Jetstream[®] CPX-1000 Release Notes

Release 3.3

Document Number 1000-A2-GK41-30
November 2003

The new PDU is shown below.

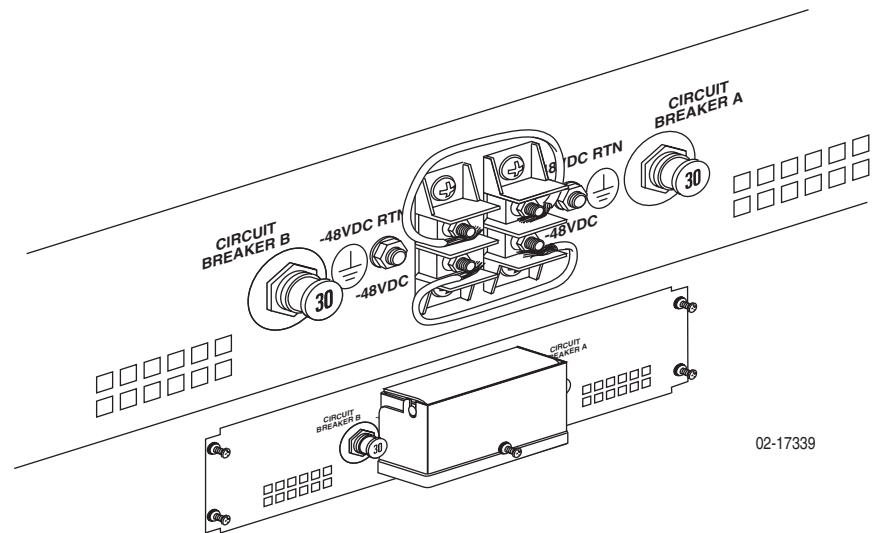
Some models of the CPX-1000 are shipped with a different type of PDU than the one shown in the user documentation.

The new PDU contains two plunger-type circuit breakers instead of one double-pole switch. To remove power from the PDU, pull each circuit breaker plunger out. To apply power to the PDU, push each circuit breaker plunger completely in and release.
